Work Order ID 79390

Item Name: 205 Skidtube bent detail

DRAWING NO. D2580	TITLE 205 SKIDTUBE ASSEMBLY	REV. E	DART AEROSPACE LTD ENGINEERING ORDER		D.E.O. NO. D2580-E-1	SHEET NO. SHEET 1 OF 1	SCALE NTS
DRAWN <i>UP</i>	CHECKED <i>ASS</i>	MFG. APPR. <i>EC</i>	APPROVED <i>[Signature]</i>		DE APPR. <i>[Signature]</i>		
DATE 11.12.13	DATE 11.12.13	DATE 11.12.13	DATE 11.12.13		DATE 11.12.13

CHANGE ALL C'BORED WELDED CROSSBOLT SPACERS TO SWAGED SPACERS

SECTION B-B D5-2
SCALE 5X

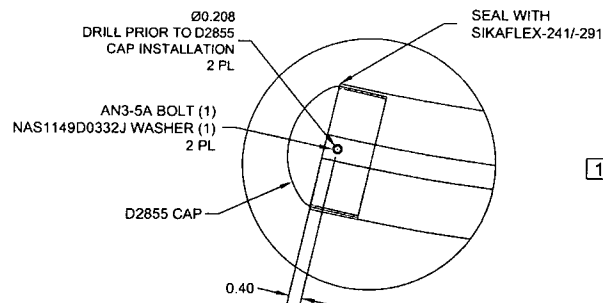
- AFTER DRILLING AND BENDING ASSEMBLY PERFORM THE FOLLOWING FOR Ø0.508 HOLES ONLY:
1. CHAMFER HOLE 0.050 X 45°
 2. INSERT D2579 SPACER (20 PLACES)
 3. WELD INTO PLACE AND GRIND FLUSH
 4. C'BORE D2579 SPACER TO Ø0.437 X 1.00 DEEP

SECTION I-I D5-7
SCALE 5X

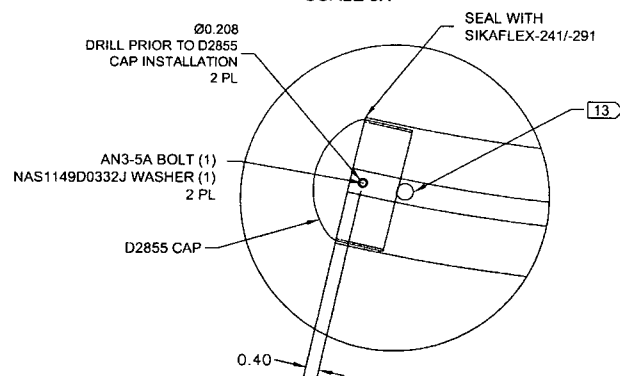
- AFTER DRILLING AND BENDING ASSEMBLY
PERFORM THE FOLLOWING FOR Ø0.508 HOLES ONLY:
1. CHAMFER HOLE 0.050 X 45°
 2. INSERT D2579 SPACER (25 PLACES)
 3. WELD INTO PLACE AND GRIND FLUSH
 4. C-BORE D2579 SPACER TO Ø0.437 X 1.00 DEEP

SECTION B-B, F-F, I-I
NOT TO SCALE

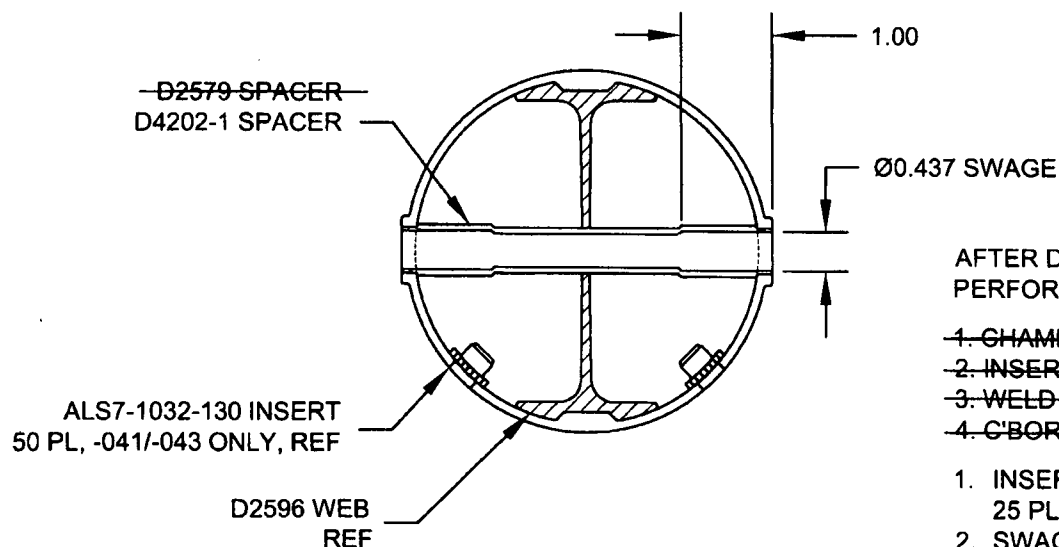
SECTION B-B, SECTION F-F, & SECTION I-I ARE AMENDED AS FOLLOWS
FOR ALL HOLES THAT WERE ORIGINALLY C'BORED:

- ~~1. CHAMFER HOLE 0.050 X 45°~~
- ~~2. INSERT D2579 SPACER (20 PLACES)~~
- ~~3. WELD INTO PLACE AND GRIND FLUSH~~
- ~~4. C'BORE D2579 SPACER TO Ø0.437 X 1.00 DEEP~~

1. INSERT D4202-1 SPACER, 20 PL (-041) OR 20 PL (-045) OR 25 PL (-047)
2. SWAGE TO Ø0.437 X 1.00 DEEP PER QSI 002
3. TRIM / GRIND FLUSH PER QSI 002
